"ESF / GROA Interface Drawing Update - FY1995"

B00000000-01717-0200-00124, Rev 00C

Design Analysis Review Summary

Design Analysis Cover Sheet

FIGURE 7-1

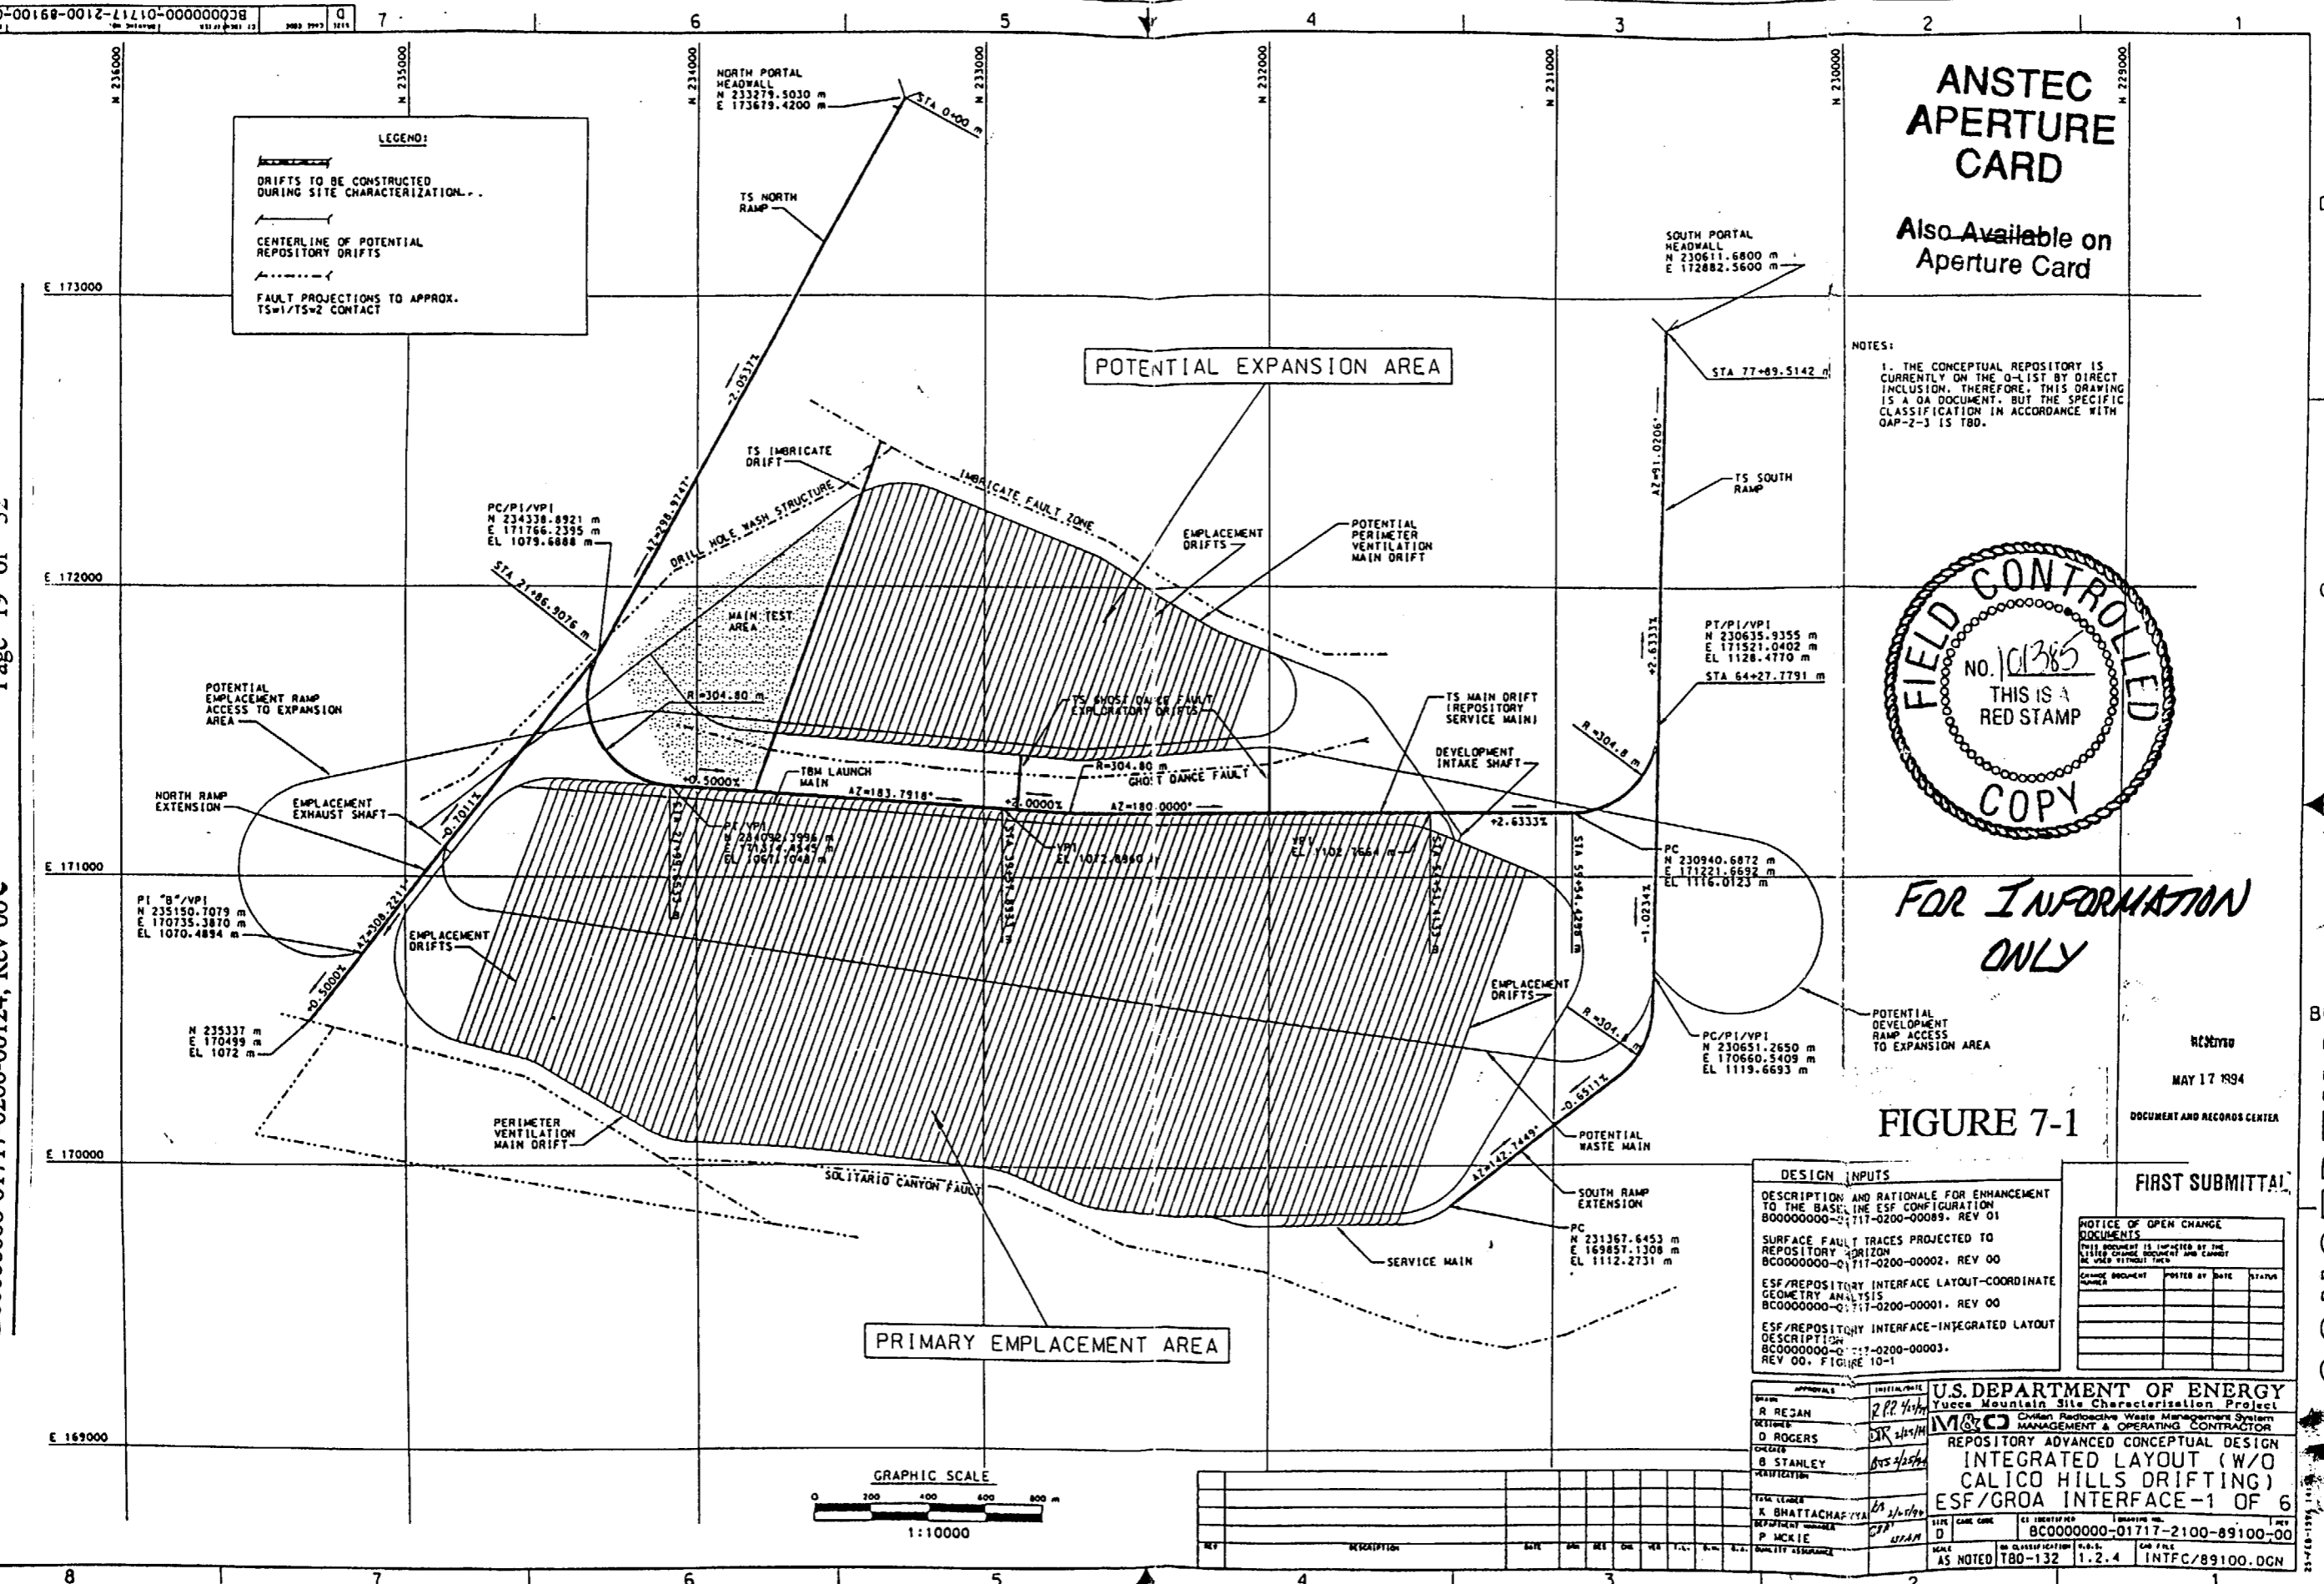
Figure 7-1 shows that the original layout contained a short horizontal curve at about the mid-point of the ESF Main Drift. This curve was originally employed to allow the main drift to better conform to the apparent non-linearity of the Ghost Dance Fault trace and thus preserve the maximum amount of emplacement area. This is because

Figures 7-1 and 7-2 show a drift, running roughly north-south, which bisects the upper block and called out as the "Potential Waste Main" on the figures. Figure 7-7 does not show this drift. This drift, if employed, would be used as an additional access to the emplacement drifts. It would, in effect, cut the length of the drifts in half. This could be an advantage if, for example, backfilling of emplacement drifts were to be required at decommissioning.

The ESF as shown on the original interface drawings contained a "South Ramp Extension" (SRE), an "Imbricate Fault Drift," and an area designated as a "Main Test Area," or MTA. These are shown on Figures 7-1 and 7-2, and a cross-section partially along the Imbricate Fault Drift is shown in Figure 7-3. A cross-section partially along the South Ramp Extension is shown in Figure 7-6.

The North Ramp Extension (NRE) is shown on Figures 7-1 and 7-2 as it was originally envisioned.

The original "loop" defined by the North Ramp, Main Drift, and South Ramp, is shown in Figure 7-1. Minor adjustments have been made to the geometry of the north ramp in addition to those resulting from the changes described in Section 7.2.1 and 7.2.2. These changes have resulted in small movements of design points. One such design point is the bottom of the North Ramp. The original interface drawings, shown in Figures 7-1 and 7-2, had this point at a Northing of approximately 234,092.4 meters, an Easting of about 171,314.5 meters, and an elevation of approximately +1,067.1 meters.

The proposed revision to the ESF/GROA interface drawings shows a straight ESF main drift from the bottom of the north ramp at approximately Station 28+04 to the bottom of the south ramp at approximately Station 56+54. See Figures 7-7 and 7-8.

The potential waste main has been removed.

The South Ramp Extension, Imbricate Fault Drift, and Main Test Area (MTA) have been dropped from the ESF configuration.

The alignment was altered at the same time as the changes described in 7.2.8. The NRE / North Ramp intersection was moved eastward, or up the ramp. The alignment was changed to show the NRE starting off at a more northerly bearing before curving back to the west and penetrating the Solitario Canyon Fault.

The proposed location of this point is now at approximately: Northing = 234,087.7 meters; Easting = 171,313.8 meters; elevation = +1065.0 meters. This location is approximately 5 meters from the original location of the point in the interface drawings.

FIGURE 7-2

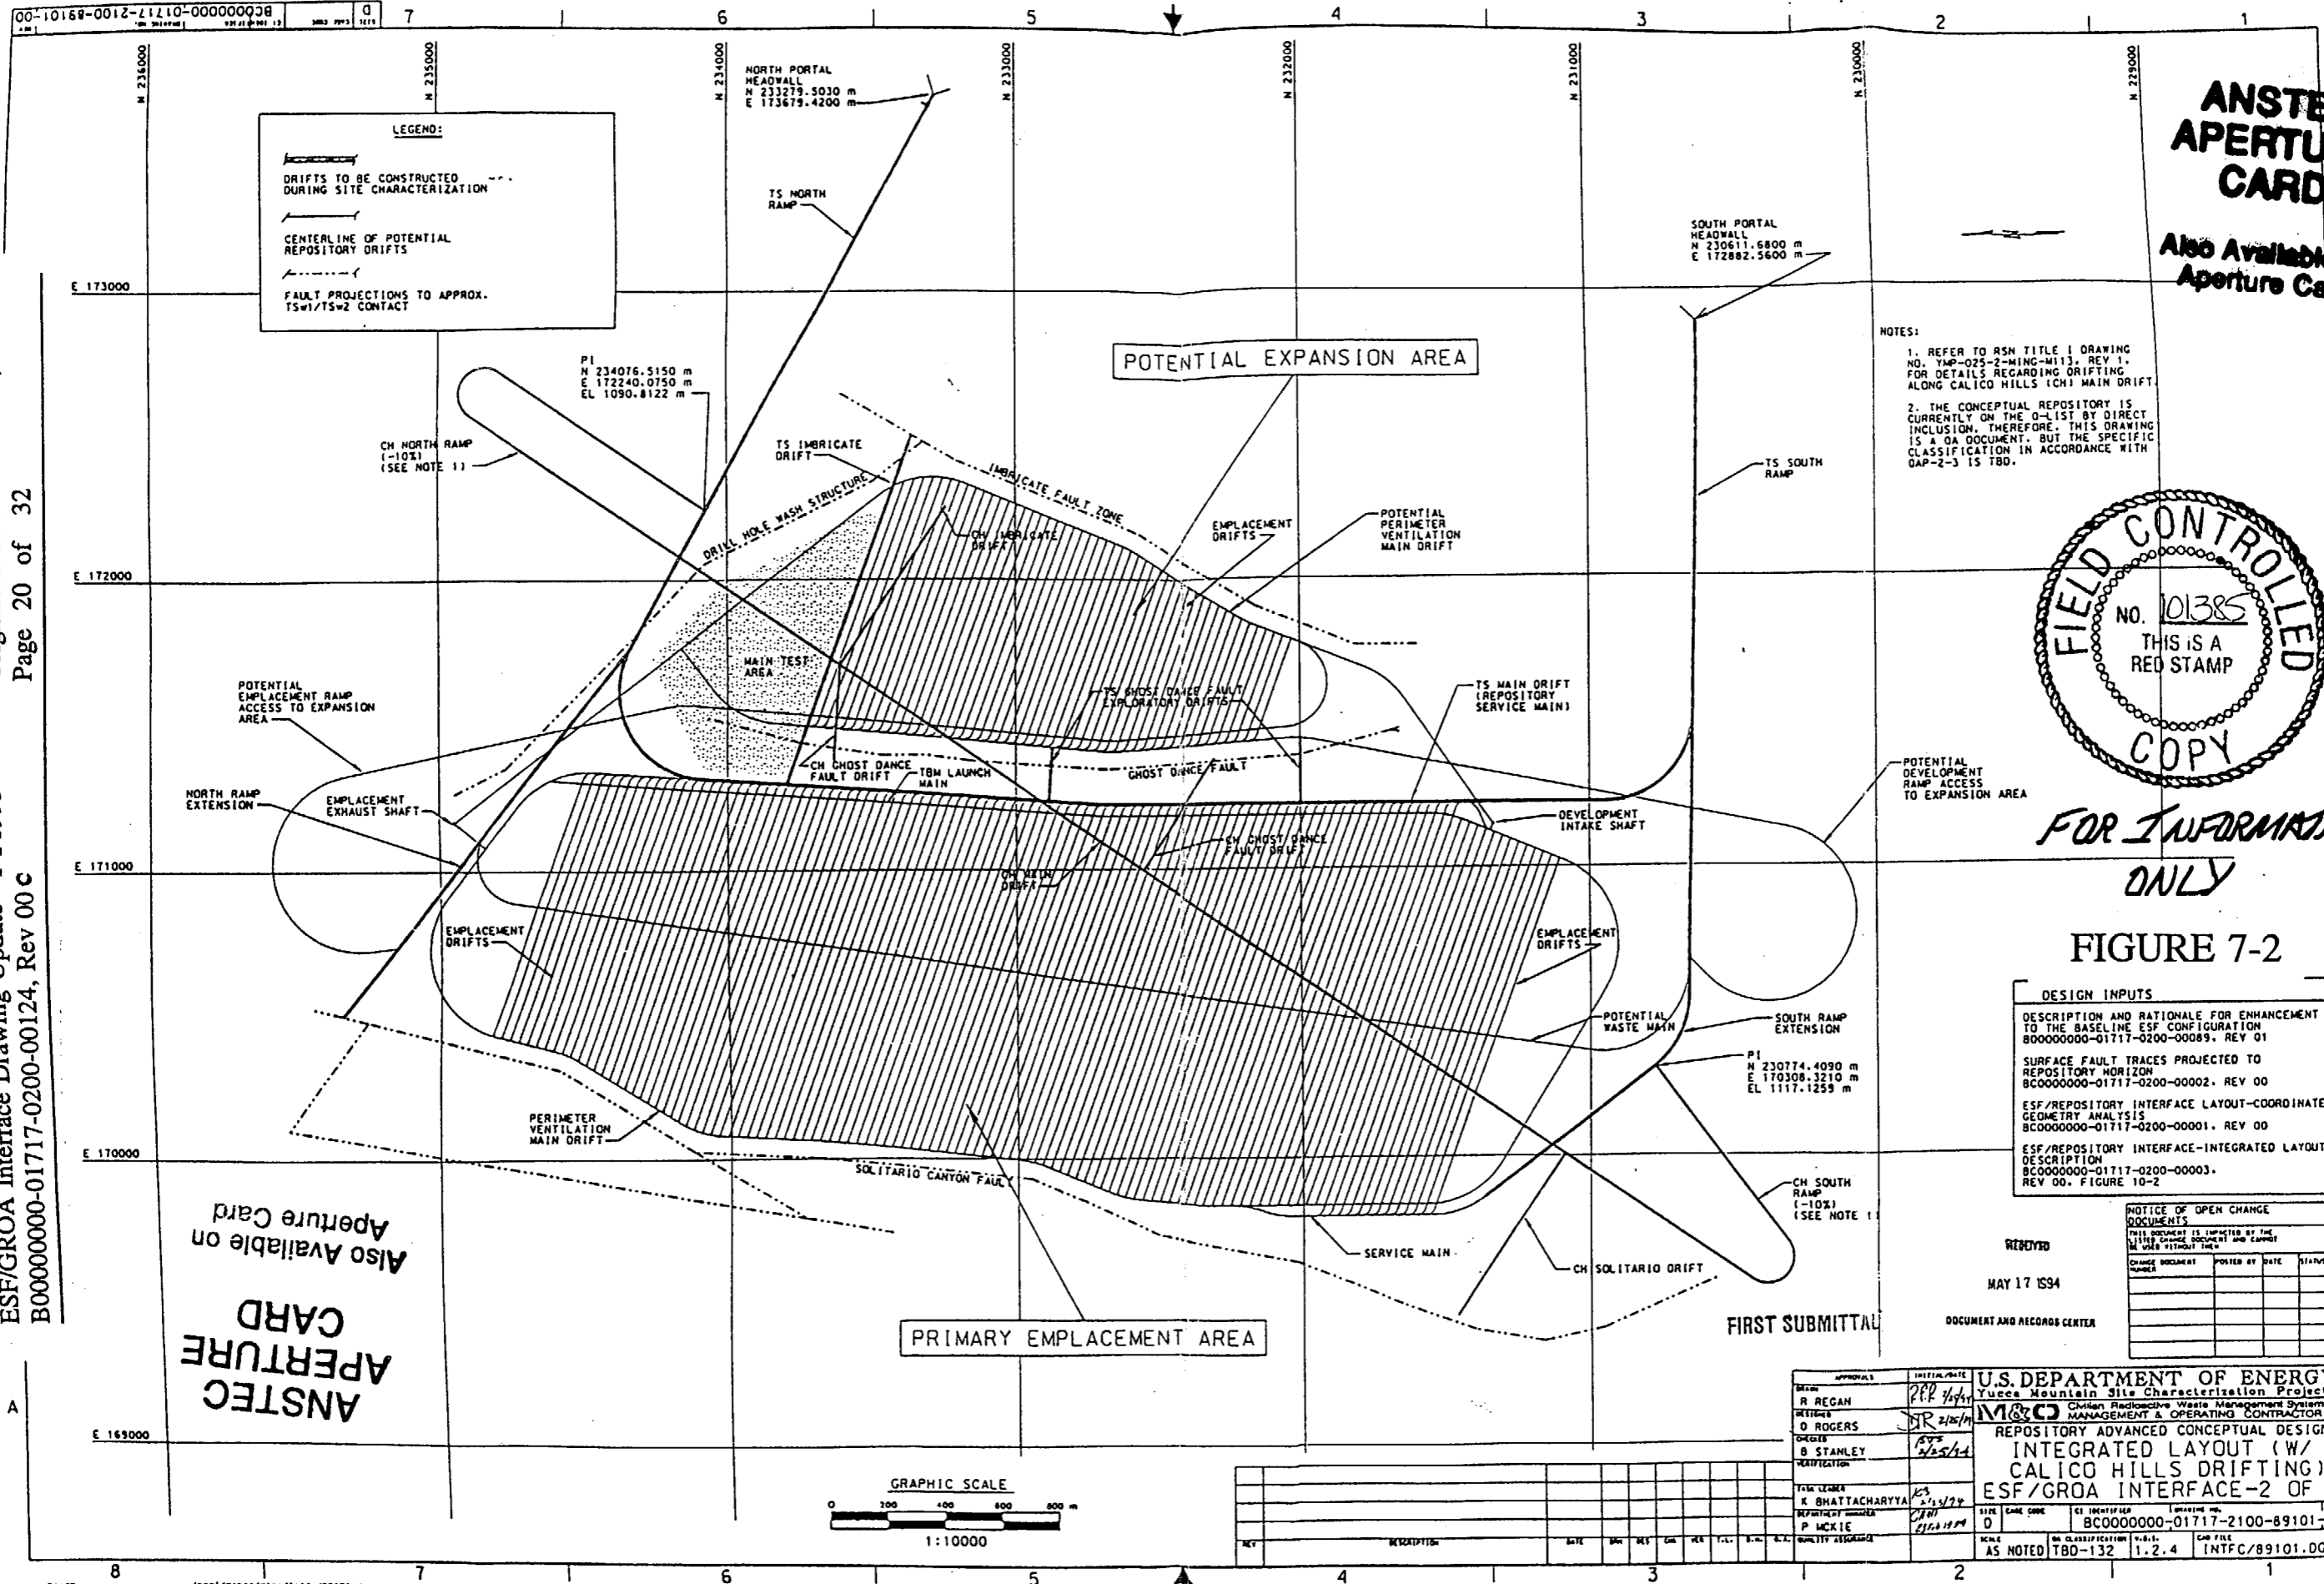
The current baseline CH access and drifting concept is shown on Figure 7-2. It consists of a CH North Ramp, originating along the lower end of the ESF north ramp; a CH Main Drift, oriented at approximately N 34° E running the length of the primary area, and a CH South Ramp, which connects with the SRE in the TSw2 level. Several side drifts are also shown to explore geologic structures. Approximately 9,635 meters of drifting is shown in this configuration.(Ref 5.18, p.17)
